CEPC TDRrd ECAL Updates

Yong Liu (IHEP) for the CEPC TDRrd ECAL team
CEPC Reference Detector TDR Weekly Meeting
November 19, 2024

Preliminary report of IDRC Review: ECAL part (1)

SiPM noise level

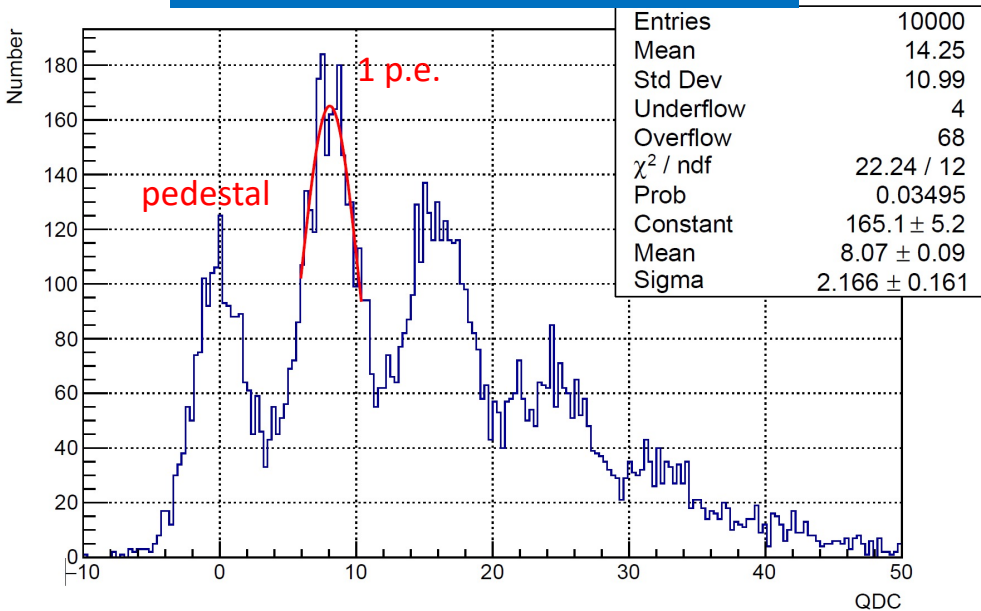
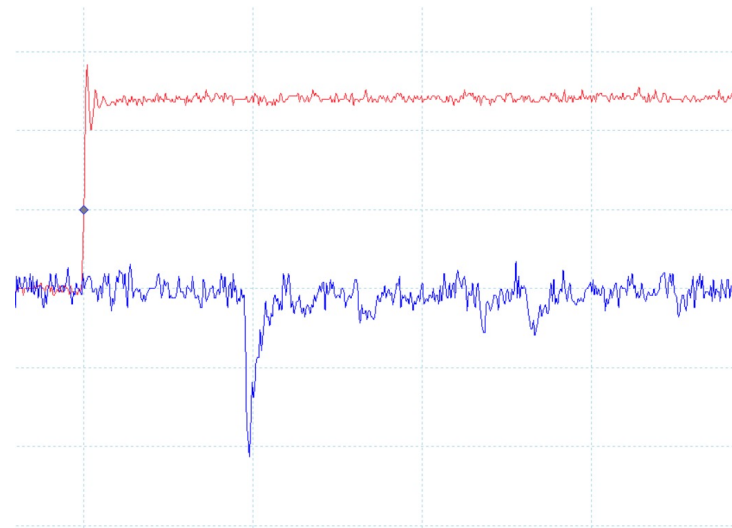
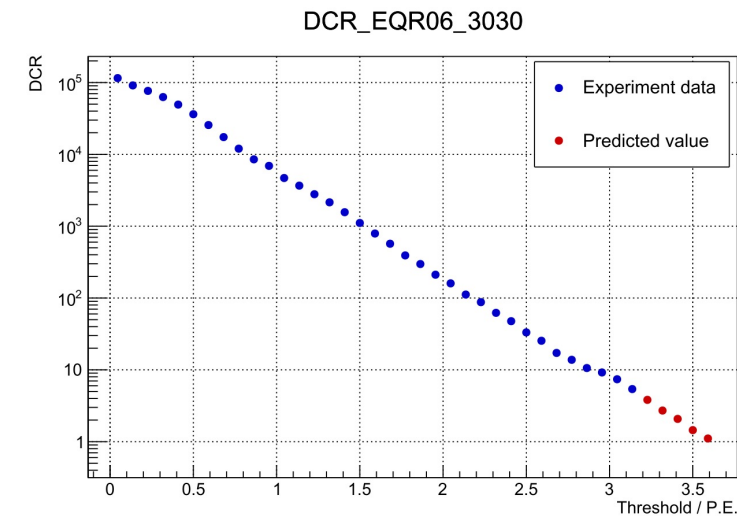
- Feedback to “The noise levels of the ECal including SiPMs and readout electronics.”

- NDL-EQR06 is the target SiPM option for crystal ECAL
 - 6 μm pixel pitch, $3 \times 3 \text{ mm}^2$ active area
 - High pixel density (244720 pixels), narrow pulse shape ($\sim 10 \text{ ns}$)
 - Negligibly low noise expected at 0.1 MIP (10 p.e.) threshold

SiPM response to BGO scintillation

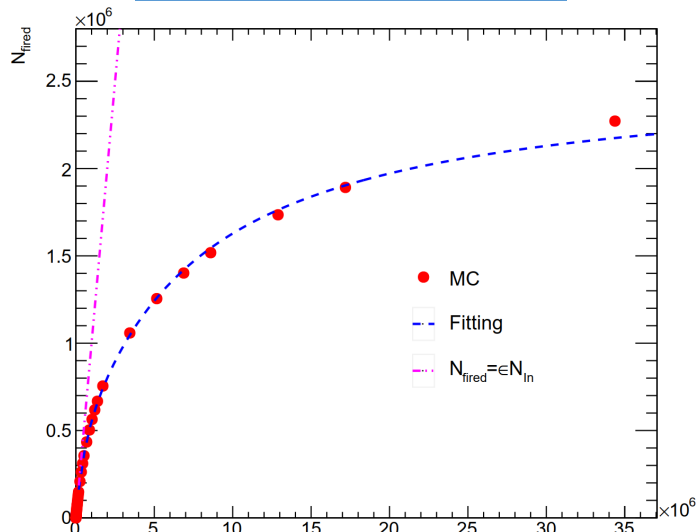
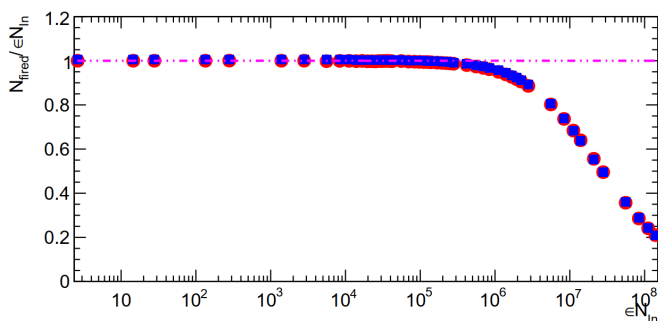
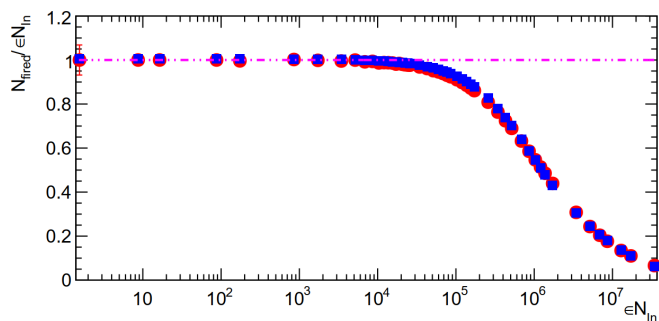
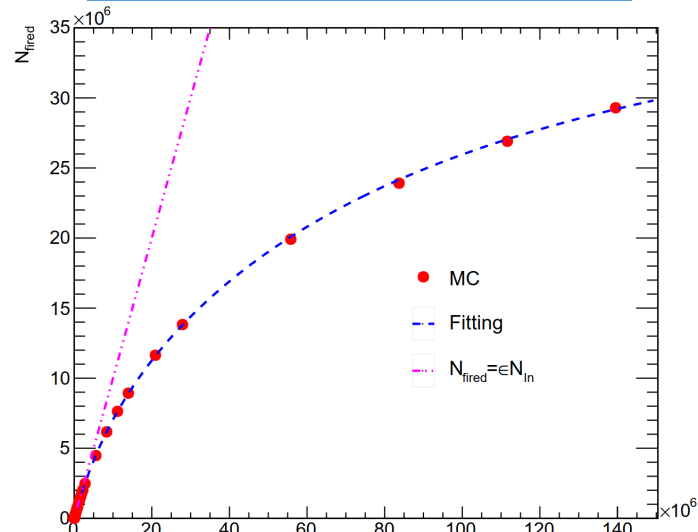
- Feedback to “*SiPM dynamic range and linearity needs specification.*”

A Monte Carlo model to simulate the SiPM response to BGO(40x40x1cm) scintillation light. The model includes both BGO and SiPM properties.

We would need to formulate specifications based on these studies

Crystal calorimeter prototype in beamtests

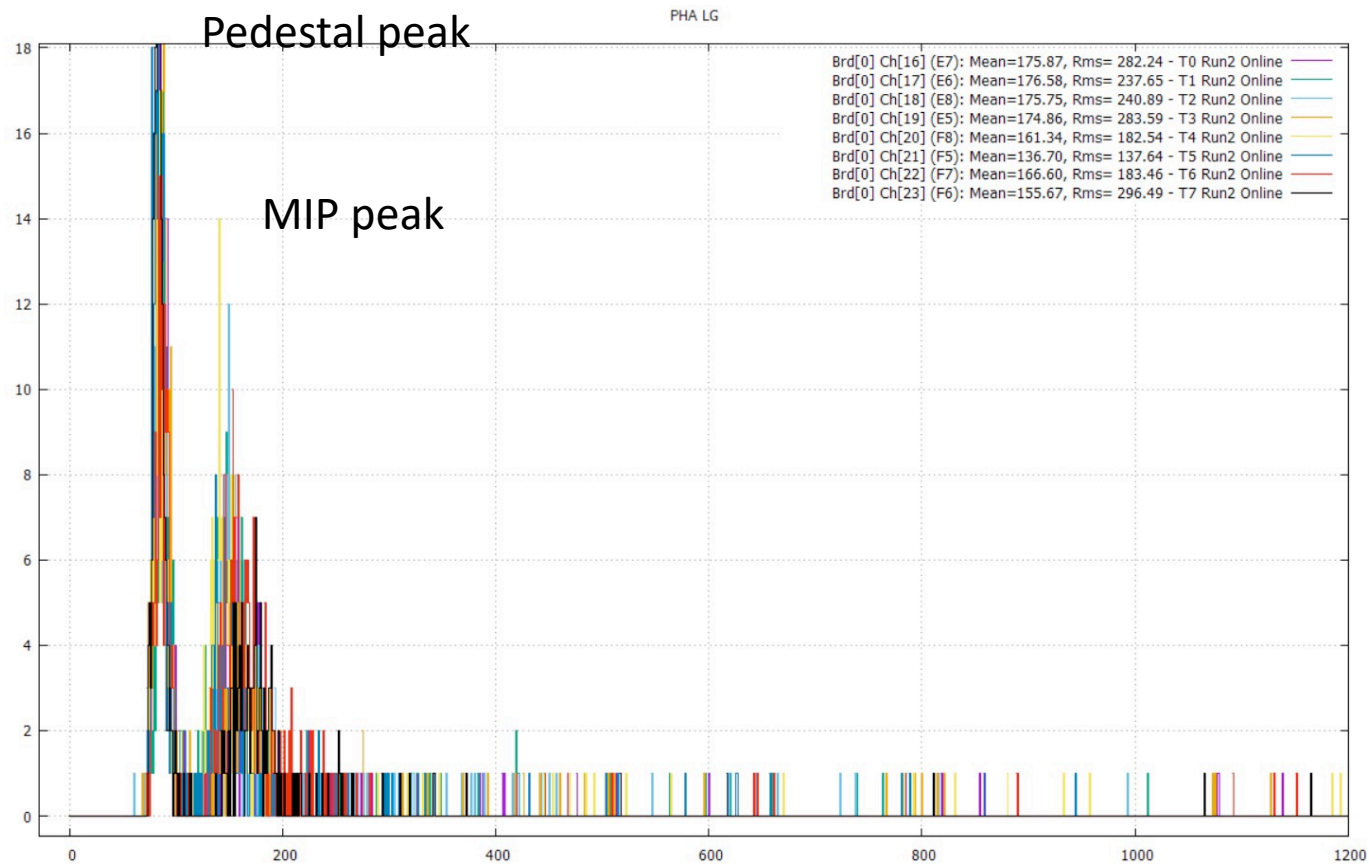
- The noise levels of the ECal including SiPMs and readout electronics

The crystal calorimeter prototype used commercially available ASICs. The S/N ratio is promising and barely noises besides pedestals

We would need to discuss with electronics team for further evaluation with custom-made designed ASIC in planning
